**PRODUCT
SUPPORT
BULLETIN # 459**

TOOL(S) \ PRODUCT(S) AFFECTED: 5359-21 1-1/8" SDS Rotary Hammer

SUBJECT: Spindle difference between revision 'A' & 'B' - 38-50-0011 Spindle / Spindle Gear Kit

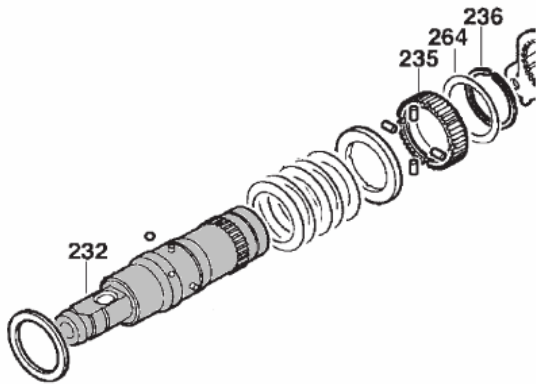
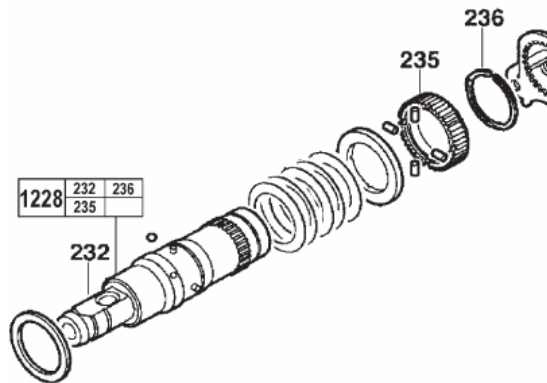
Revision 'A' 38-50-0038 Spindle - Spindle Gear 22-75-1207 (fig. 235) contains a recess for flat Washer 45-88-1181 (fig. 264) and a **FLAT Retaining Ring** 44-90-4510 (fig. 236) is used to secure spindle gear to the spindle. Note: original equipment 38-50-0038 Spindle is replaced by a **38-50-0011 Spindle Kit**, which updates to revision 'B' Spindle / Spindle Gear.

Revision 'B' 38-50-0058 Spindle - **no recess** in Spindle Gear 32-10-0055 and **no washer** is being used; (fig 236) is a **ROUND Retaining Ring** 40-50-8492
